ENVIRONMENTAL IMPACT REPORT

CRYSTAL BAY

STOCKTON, CALIFORNIA

EIR FILE NO. 6-05

FIGURE 3.5.1

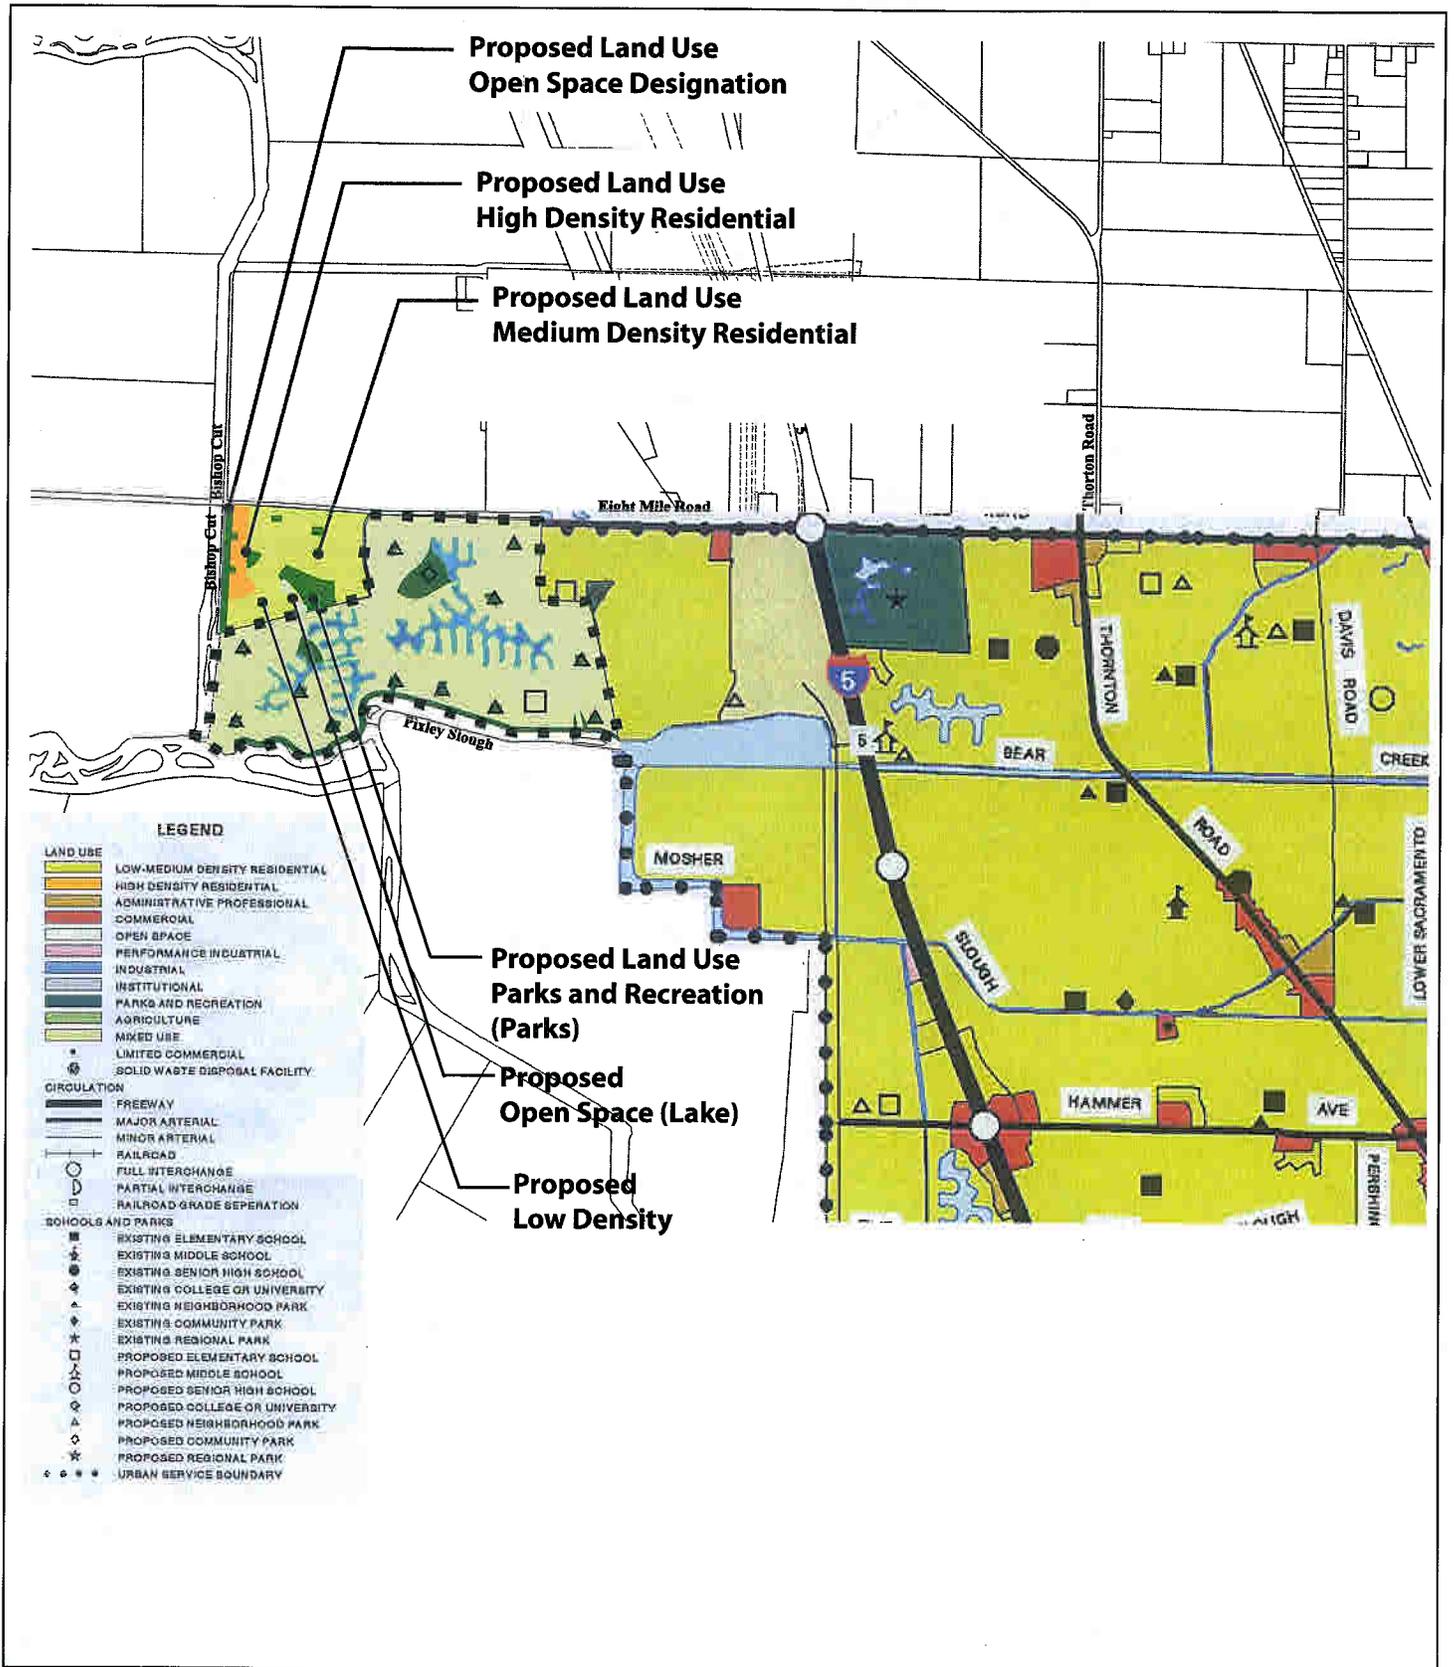
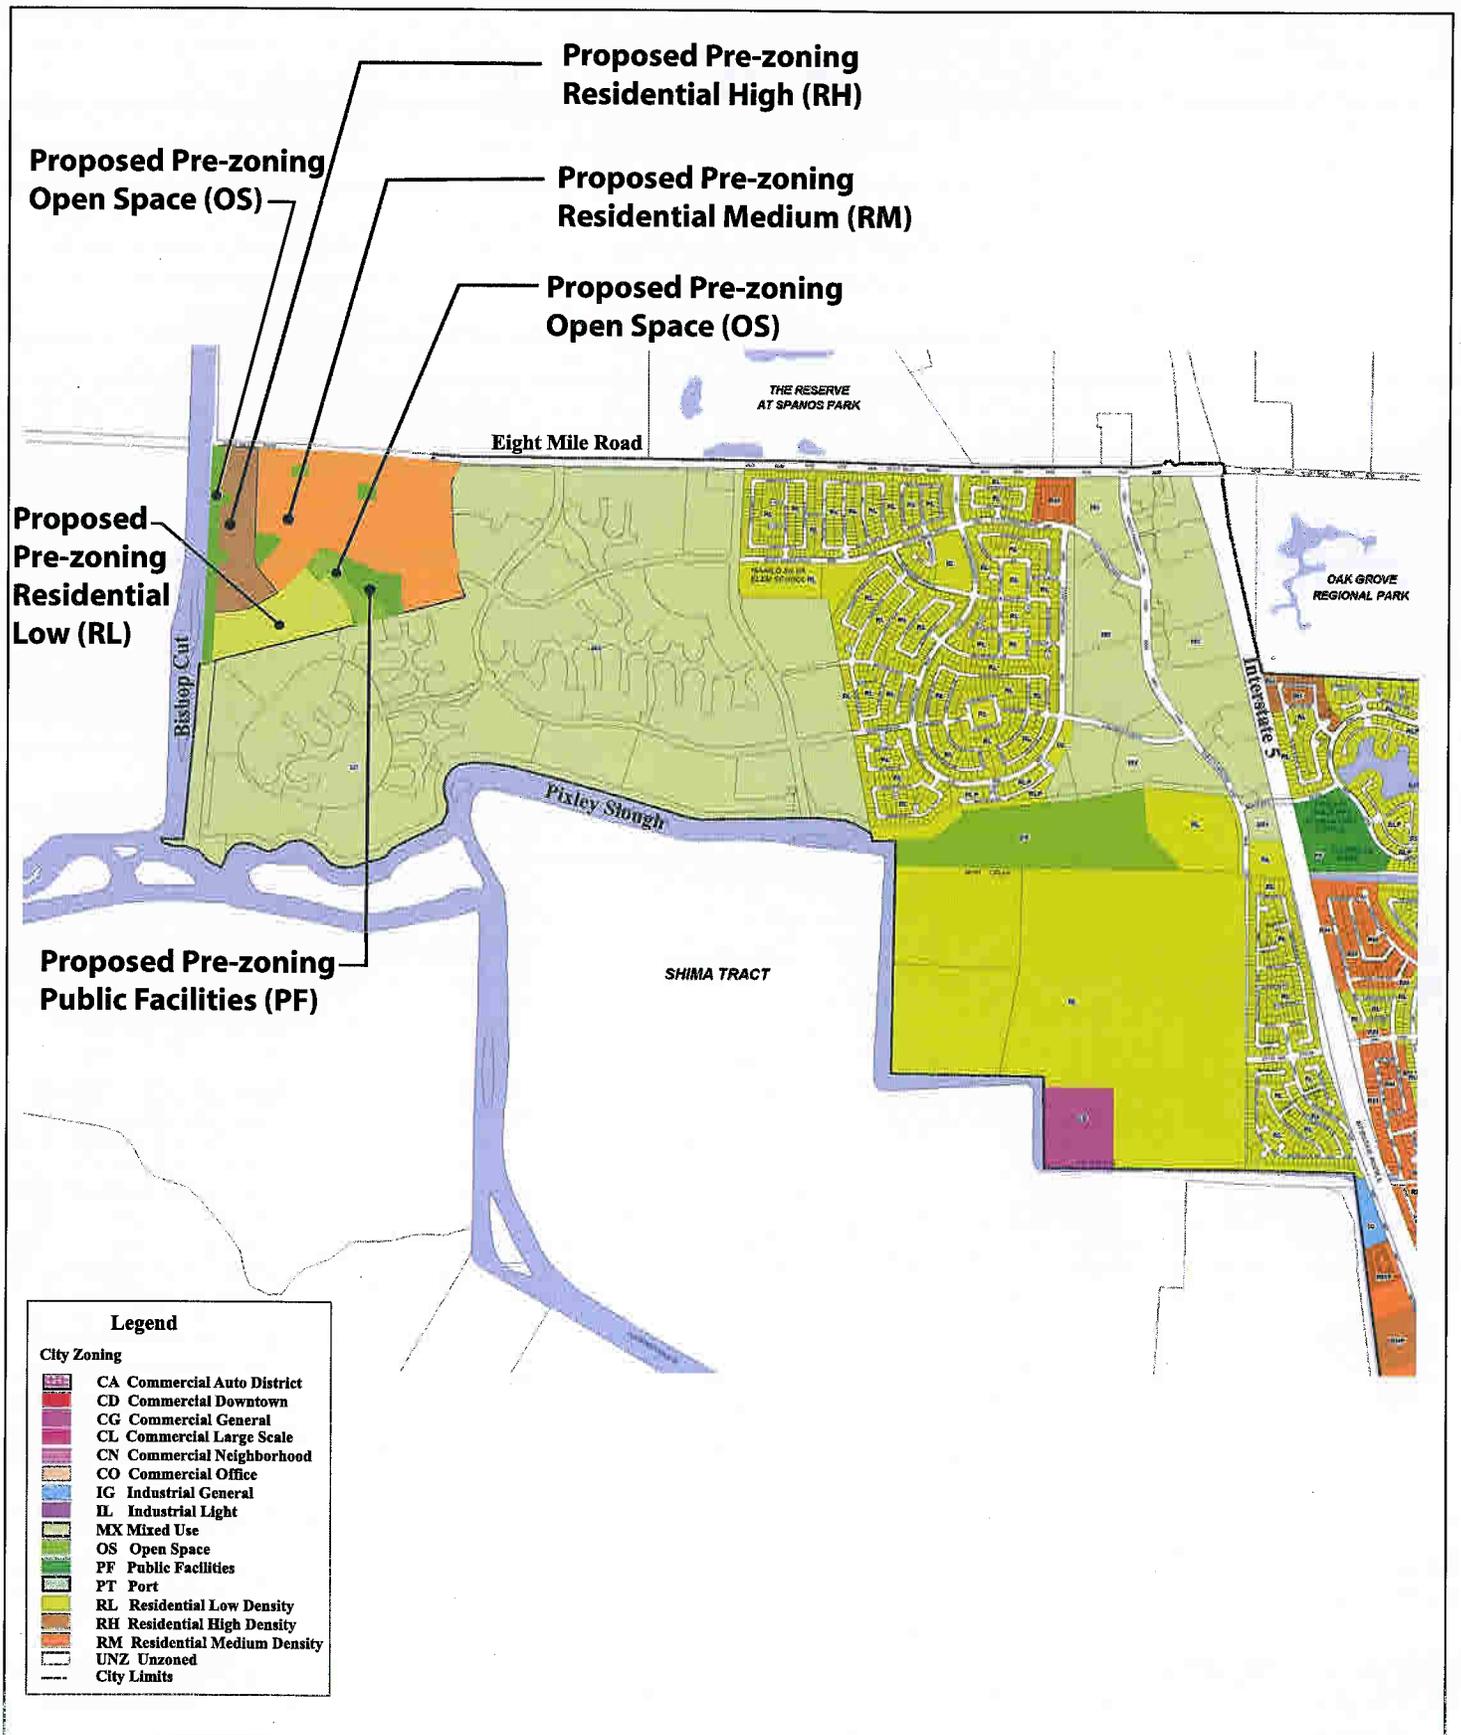
The following figures have been revised:

Figures 3.5.1 and 3.5.2 have been revised. See attached figures for changes.

Figure 5-5

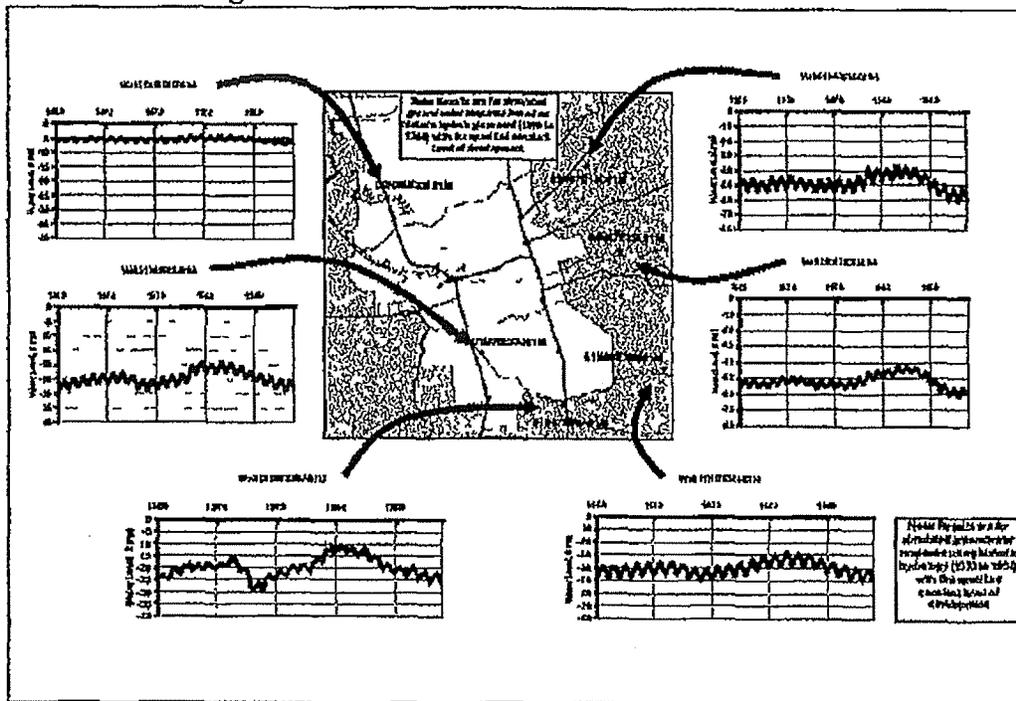
Figure 5-5 of this report, reproduced below, illustrates the simulated responses to the groundwater basin represented by six wells located in and around the COSMA. This figure shows that, despite the City's claim that the portion of the groundwater basin under the COSMA is "stabilized" and at "equilibrium", groundwater levels have continued to decline, and the rate of decline is increasing. Unless substantial amounts of surface water are imported into the COSMA to reduce groundwater pumping and offset this trend, growth contemplated by the General Plan

2035 DPEIR and this CBMDP DEIR will cause an even more rapid decline in groundwater levels. Declining groundwater levels will result in (1) increased pumping costs for all existing residential, commercial, agricultural and industrial users due to increased hydraulic lift, (2) decreased yields due to decreased aquifer saturated thickness, and (3) greater tendency for eastward migration of saline water from the west due to a steeper hydraulic gradient. Eastward movement of salinity will threaten and eventually eliminate many existing municipal wells on the westward edge of the COSMA as salinity exceeds the maximum contaminant levels set by the State for drinking water.

MA-18

Figure 5-7
 Simulated Groundwater Level Response
 Comparison of Project and No Project - 2050 Cumulative Conditions

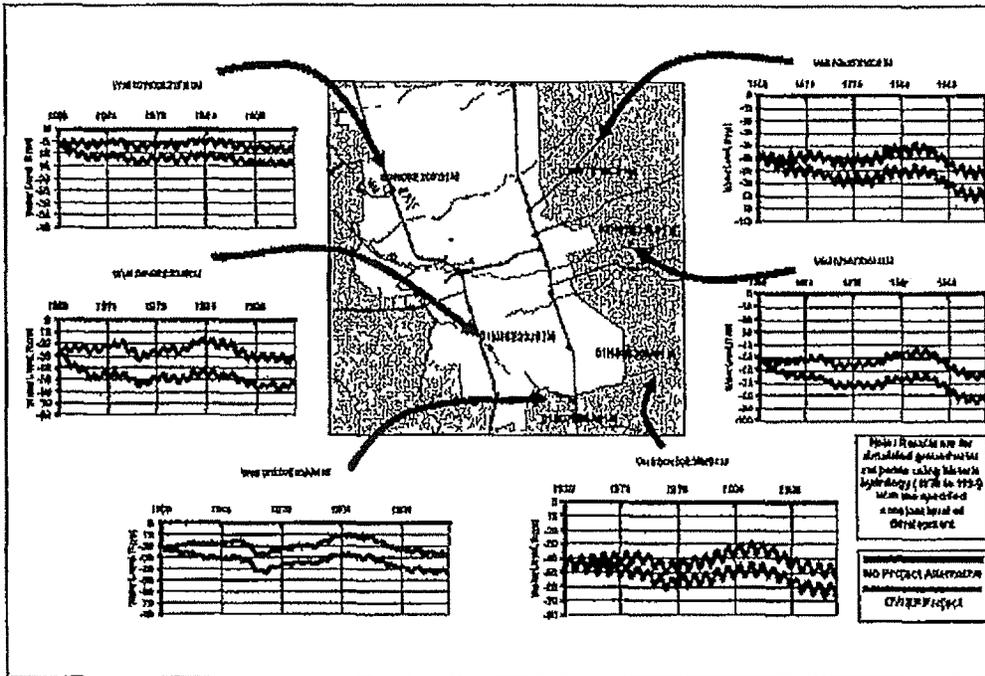
Figure 5-7 reproduced below illustrates the effect on groundwater if growth contemplated in the GPU-2035 continues until 2050. Also illustrated is the effect of the importation of surface water developed from the proposed Delta Water Supply Project at the Delta Water Supply's ultimate development. This figure shows that, even in the unlikely event of full development of the water supply contemplated by the Delta Water Supply Project, groundwater levels will continue to decline, although, of course, groundwater levels would be significantly improved by the addition of this surface water. However, as noted above, it is highly unlikely that the City will ever be able to achieve the level of importation of Delta water contemplated and desired, due to the restriction on pumping during "balanced conditions" in the Delta. Furthermore, the figure assumes that the City will be able to recharge the groundwater aquifer with any surface water pumped from the Delta and not immediately needed by water users within COSMA. The City

MA-19

does not have the rights for this additional water over and above the Phase I Project, nor does it have the right to store this water underground, or have any project or system contemplated to do this. Therefore, what can only be predicted from the impact of population growth projected from the GPU-2035 is an average of a 20 foot decline in groundwater levels by 2050.
